ORISE
OAK RIDGE INSTITUTE FOR SCIENCE AND EDUCATION

**SUBJECT: CONFIRMATORY RADIOLOGICAL SURVEY OF THE WET
CERAMICS AREA, CIMARRON CORPORATION FACILITY,
CRESCENT, OKLAHOMA - FINAL REPORT**

**CONFIRMATORY RADIOLOGICAL SURVEY
OF THE
WET CERAMICS AREA
CIMARRON CORPORATION FACILITY
CRESCENT, OKLAHOMA**

FIGURE 5: Wet Ceramics Area, Concrete Pads and Girders - Surface Soil Sampling Locations

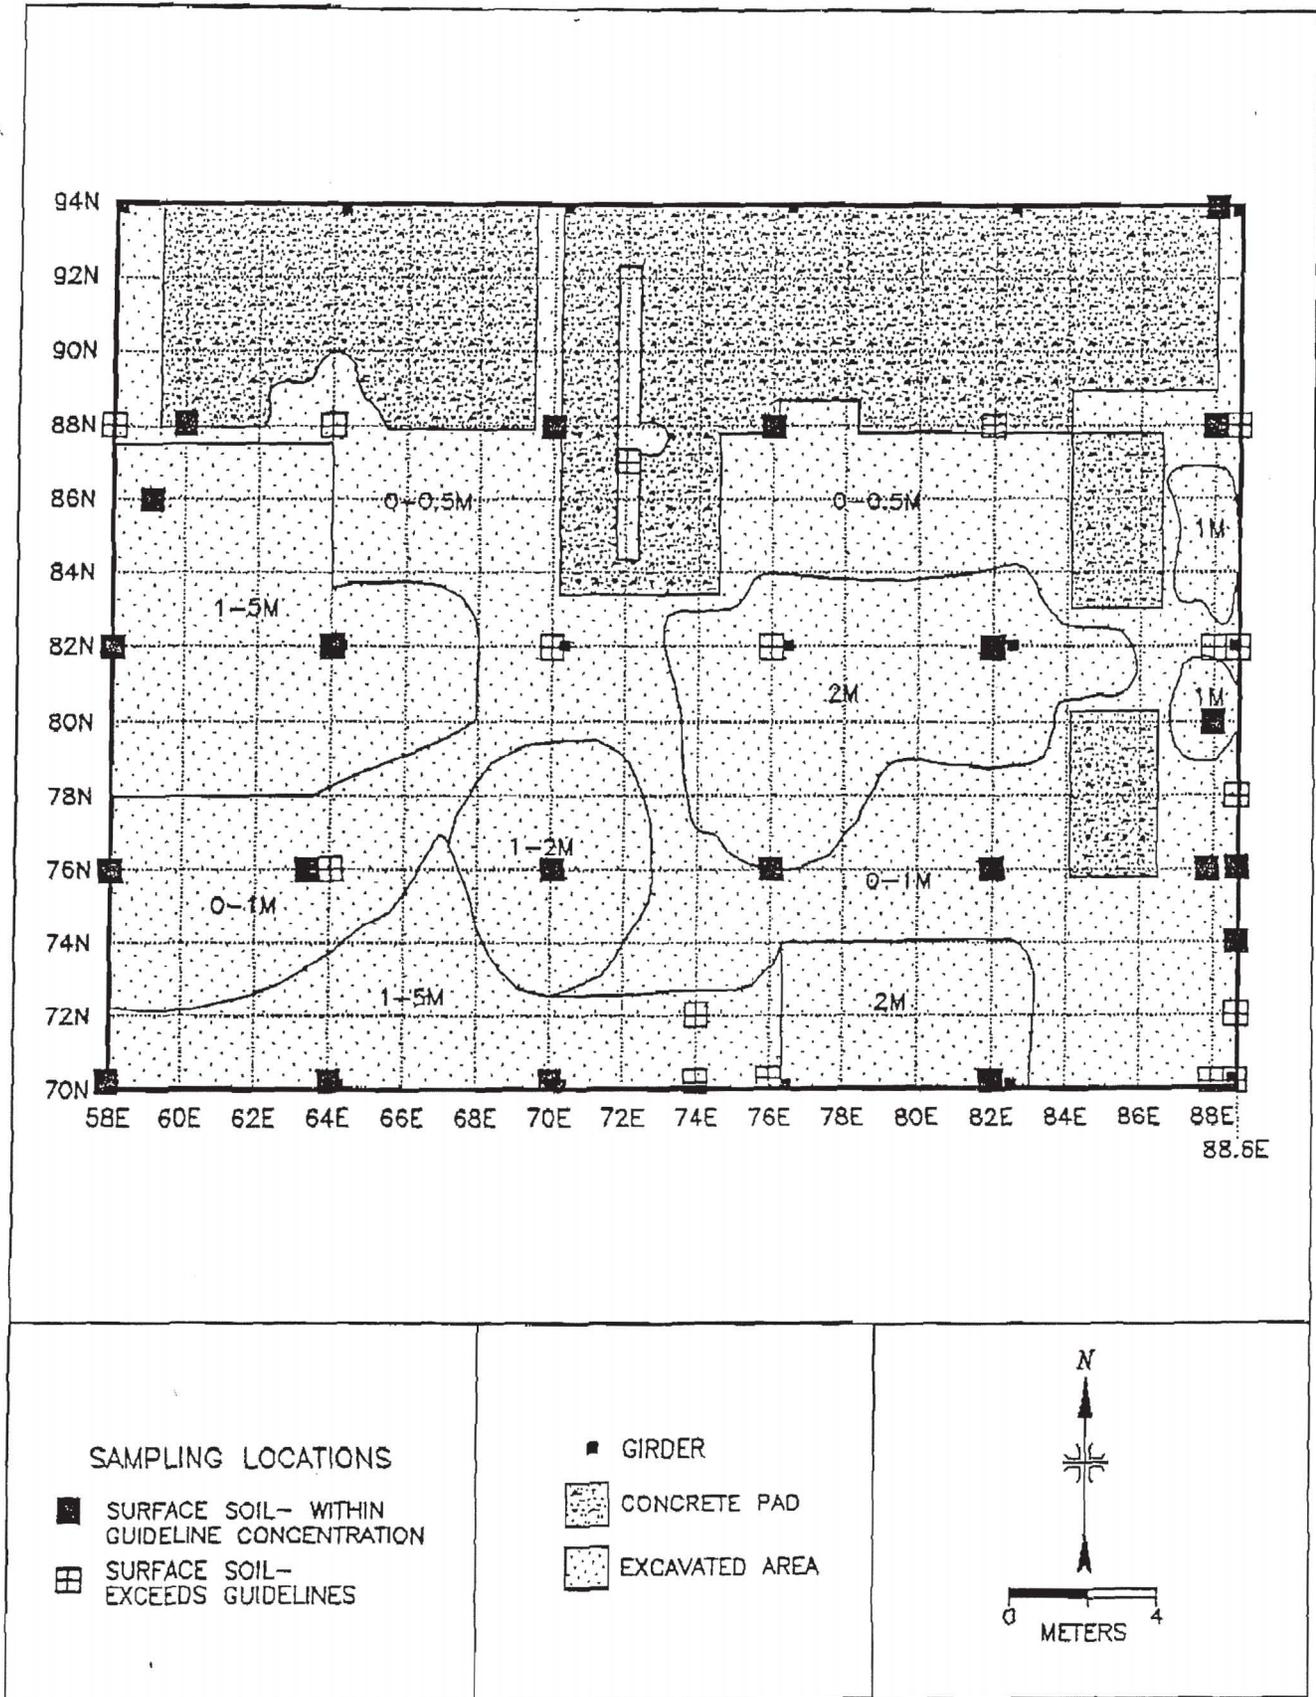
Concentrations of radionuclides in surface soil samples are summarized in Table 2. Concentrations ranged from 0.1 to 6.1 pCi/g for U-235, 1.0 to 49 pCi/g for U-238, and 3.6 to 200 pCi/g for total uranium. The highest concentration was identified at grid coordinate 72N, 88.6E.

Gamma spectrometry analysis identified 15 surface soil samples and 1 subsurface soil sample with total uranium concentrations exceeding the guideline value. The surface soil samples which exceed the guidelines were collected from 70N, 74E; 70N, 88E; 70N, 88.6E; 72N, 74E; 72N, 88.6E; 76N, 64.2E; 78N, 88.6E; 82N, 76E; 82N, 84E; 82N, 88.6E; 86N, 59E; 87N, 72E; 88N, 58E; 88N, 82E; and 88N, 88.6E. The subsurface soil sample which exceeds the guideline value was collected from 82N, 84E (0-30 cm). Alpha spectrometry analysis identified one surface soil sample which exceeded the guideline value for uranium (82N, 88E).

Five samples contained total uranium concentrations exceeding 3 times the guideline level, i.e., greater than 90 pCi/g; four of these five samples were obtained adjacent to the east wall of the building. Further evaluation of soil concentrations, performed at the request of Region III, indicated two ~ 100 m² areas with a weighted average uranium concentration above 39 pCi/g; these were 80-90N, 68-78E (37 pCi/g) and 80-90N, 78-88E (88 pCi/g).²

FIGURE 6: Wet Ceramics Area, Concrete Pads and Girders - Subsurface Soil Sampling Locations

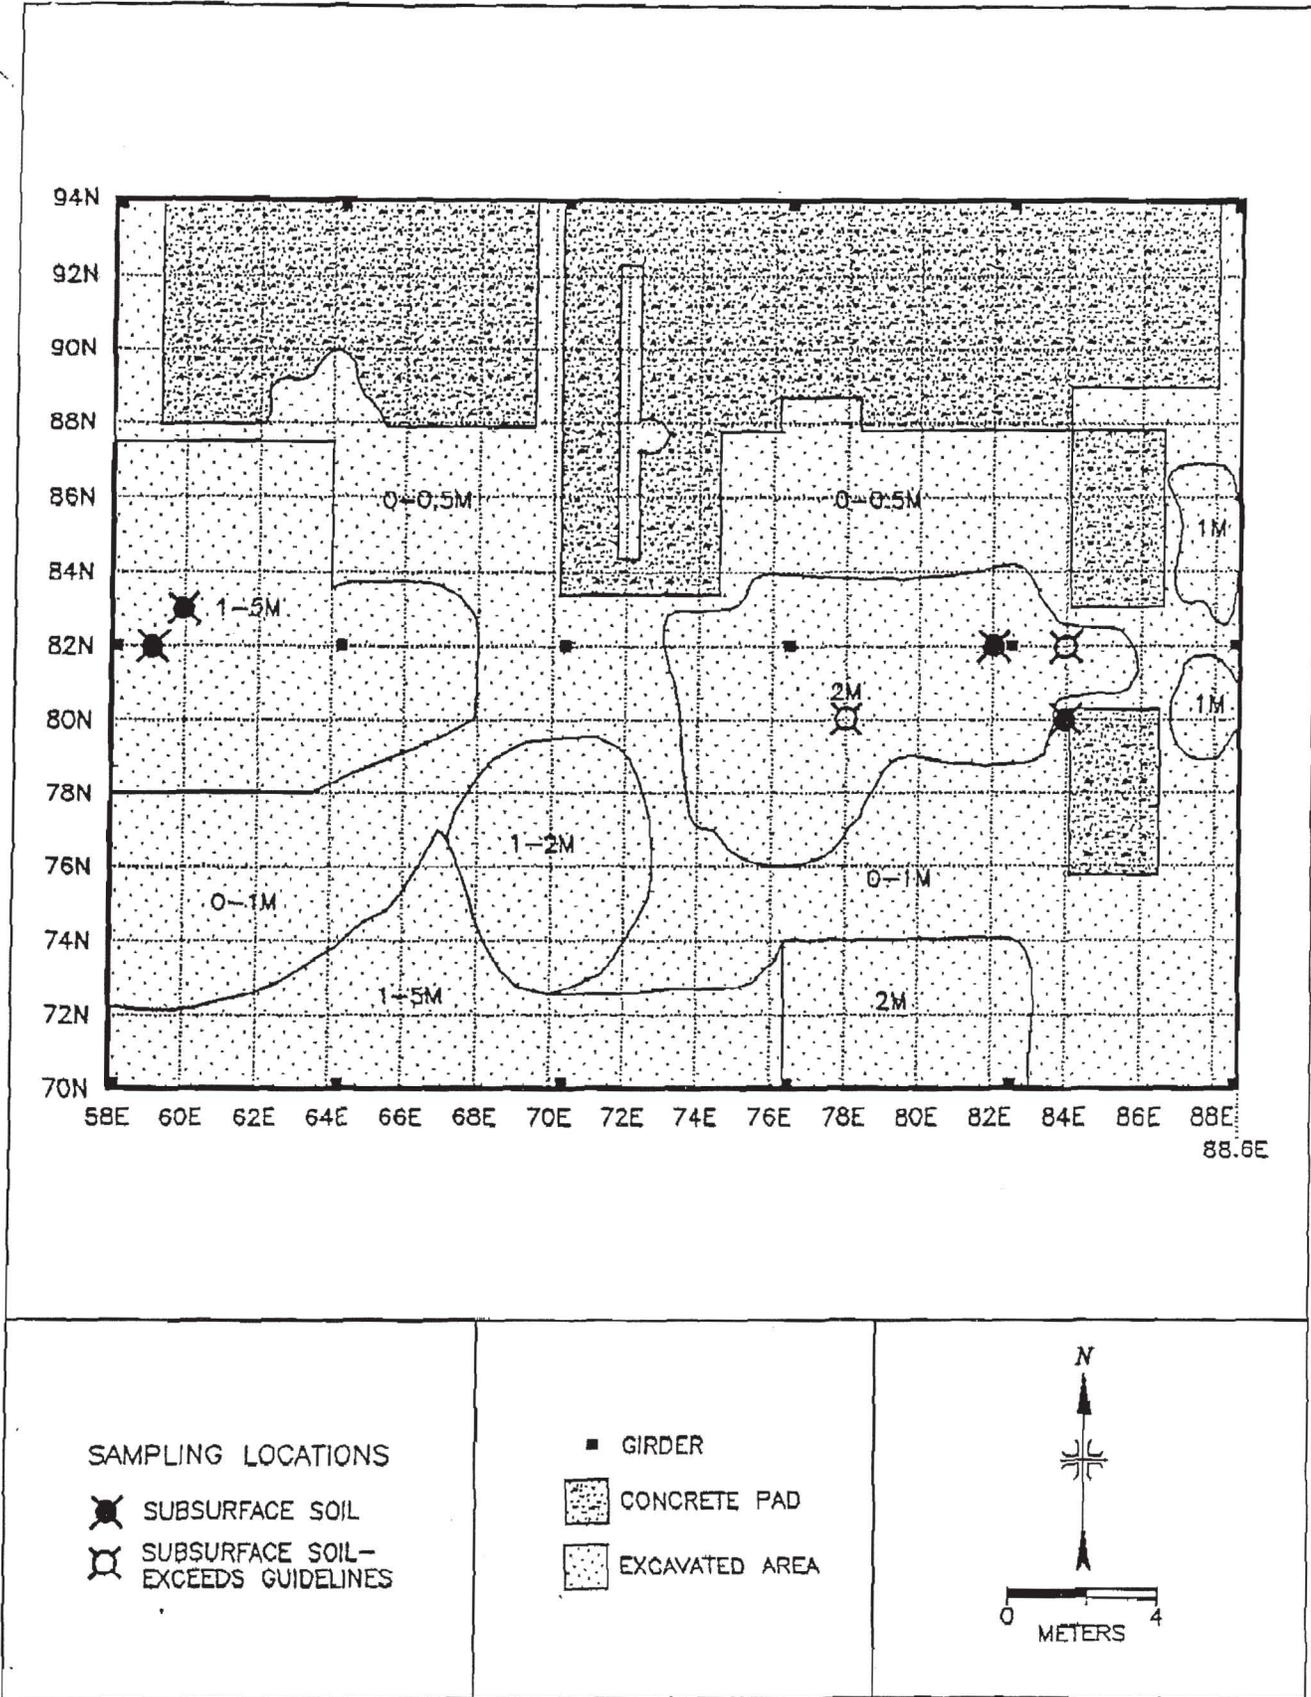
Radionuclide concentrations in subsurface soil samples are summarized in Table 3. Concentrations ranged from 0.1 to 4.3 pCi/g for U-235, 1.5 to 45 pCi/g for U-238, and 4.3 to 160 pCi/g for total uranium. The highest concentration was at coordinate 82N, 84E, at a depth of 0-30 cm.
